**Proposed Residential Development at  
at Gordon Park, Old Naas Road, Kingswood, Dublin 22  
for Greenwalk Development Ltd.**

**ADDITIONAL INFORMATION - Ref. SD21A/0327**

**Figure 4.1: Existing boundary gate at south-east of site – surveyed levels and photograph**

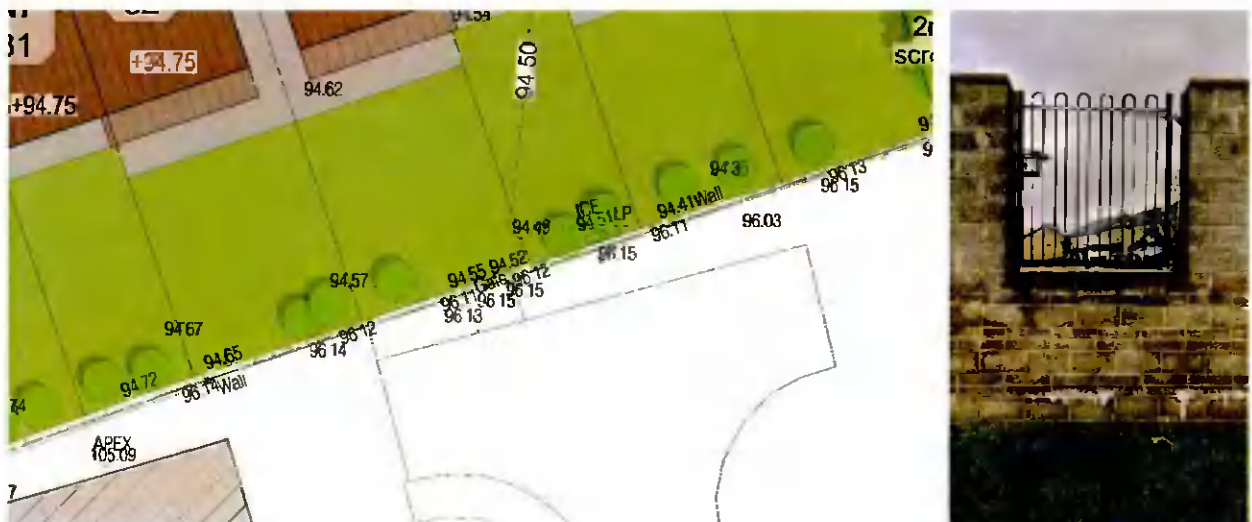
*(i) The pedestrian connections to the south should be agreed with the adjoining management company and provided as part of the development – in particular, the south-east connection as proposed does not match the existing boundary gate connecting the development to the south with the rugby pitches. These spaces should link up and if possible the adjoining public open spaces should form a single larger space. The applicant should progress this issue and provide a response via additional information. Note: It is noted that the development to the south is due to be taken in charge as per the details of that permission, but that open spaces will remain in the charge of an Owner's Management Company.*

**(b) (i)** At the existing south-east boundary gate, there is a 1.6m difference in ground level between the application site and the adjoining Silken Park development, the application site being the lower (see figure 4.1 below).

As can be seen, the existing gate opens onto the road hammerhead of Silken Park and not onto the open space to its east. As recommended, the proposed development provides for the facilitation of connections into the adjoining development via the linking up of the open spaces and for this reason it is proposed that a path within the proposed open space gently rises to connect directly with the Silken Park open space, subject to the agreement of the neighbouring Management Company (see figures 4.2 and 4.3 below).

Figure 2 – Layout of Petrol/Oil Separator

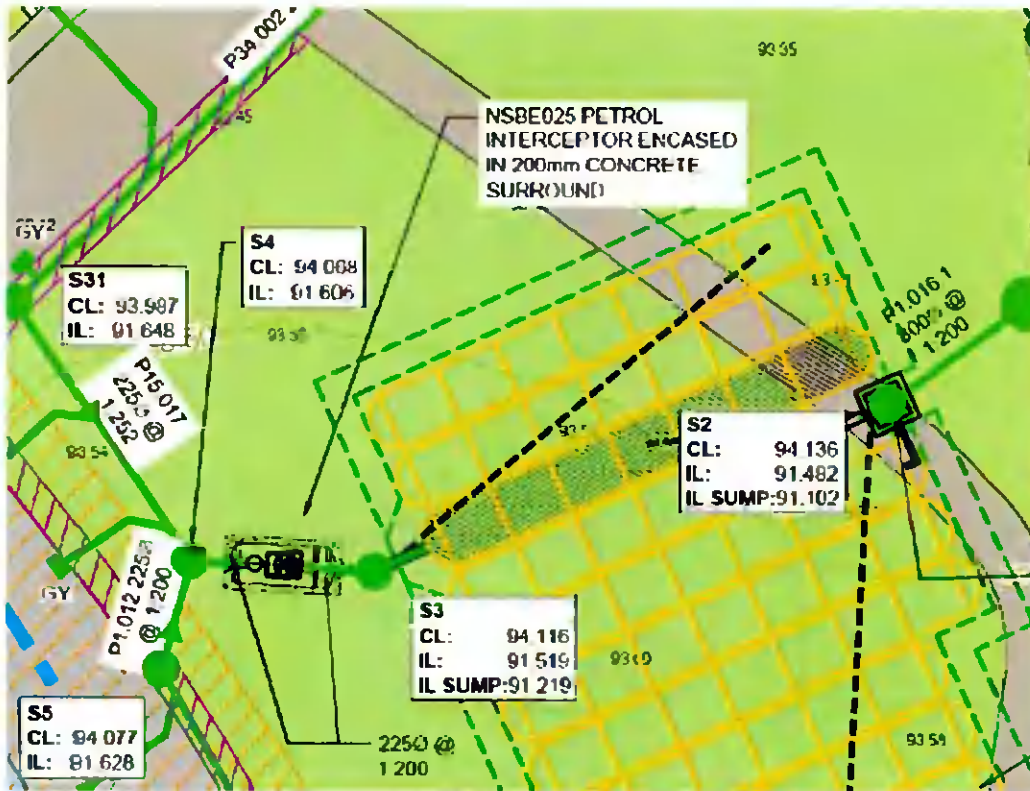
*(c) The applicant is requested to clarify and illustrate on a drawing if a petrol interceptor is proposed prior to entry of surface water to arched type proposed attenuation systems. A suitable sized petrol/oil interceptor should be proposed.*

A petrol/oil interceptor was shown on Drg 21003-TJOC-ZZ-ZZ-DR-C-0065 which was included in the original planning submission. This drawing has been updated as set out above and the revised drawing is included in the response to the Additional Information request. An extract from the drawing is enclosed below for reference also. A Klargestor NSBE025 Petrol/Oil interceptor is proposed to be installed at the upstream end of the arched type attenuation system. The interceptor has been sized based on the contributing surface area of the site and the flow rate in the surface water system.

Figure 3 – Location of Surface Water Flow Control Device

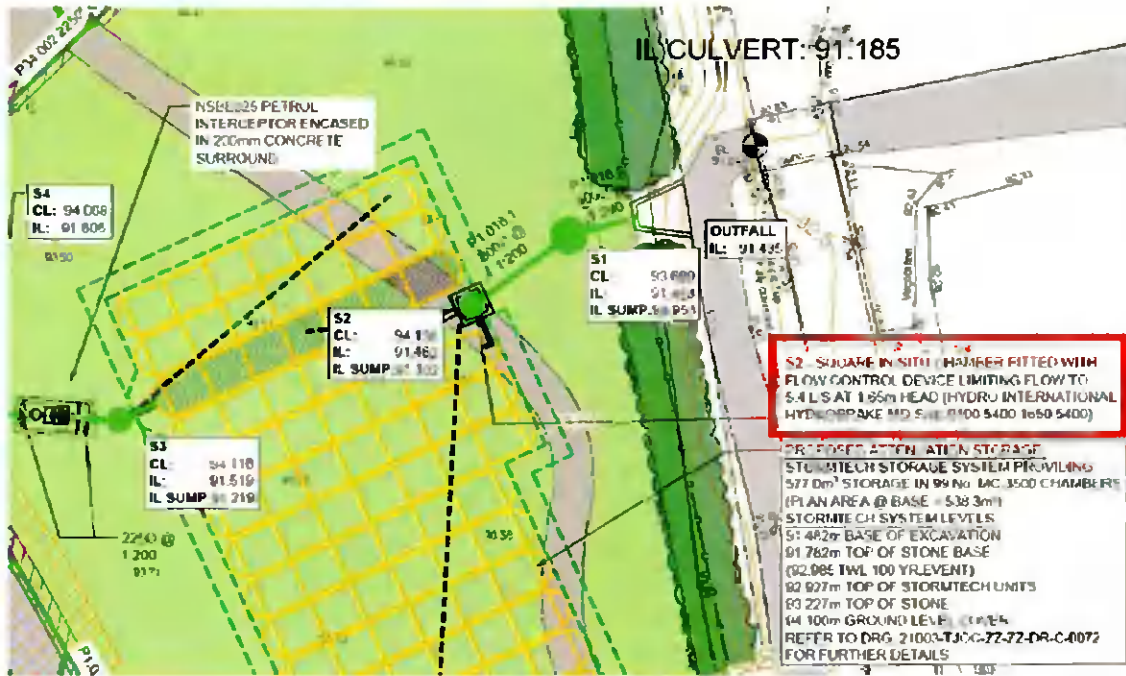
*(d) Water Services of SDCC estimate that surface water discharge should be limited to 5.1 litres/ second and not 6.5 litres/second as proposed on drawing number 21003-TJOC-ZZ-DR-C-0065. The applicant is requested to submit a report and drawing to explain this difference and adjust where necessary.*

A flow control device with a surface water discharge rate of 5.4 l/sec was shown on Drg 21003-TJOCZZ-ZZ-DR-C-0065 which was included in the original planning submission. A second flow control device was also indicated on this drawing. The purpose of the second flow control device was to hold back and control surface water flow in the surface water network within the site. The limit set for the second flow control device is 6.5l/sec. However, there is only one surface water discharge point from the site and the flow control device at this point is set at 5.4l/sec.

The discharge rate of 5.4l/sec was determined using the HR Wallingford Greenfield run-off rate calculator. This calculation was included in the Engineering services report in the original planning submission and is appended to this letter also. The site parameters used to determine the greenfield run-off rate are set out overleaf.

We refer to the extract below which shows the location of the flow control device that limits the surface water discharge from the site to 5.4l/sec.
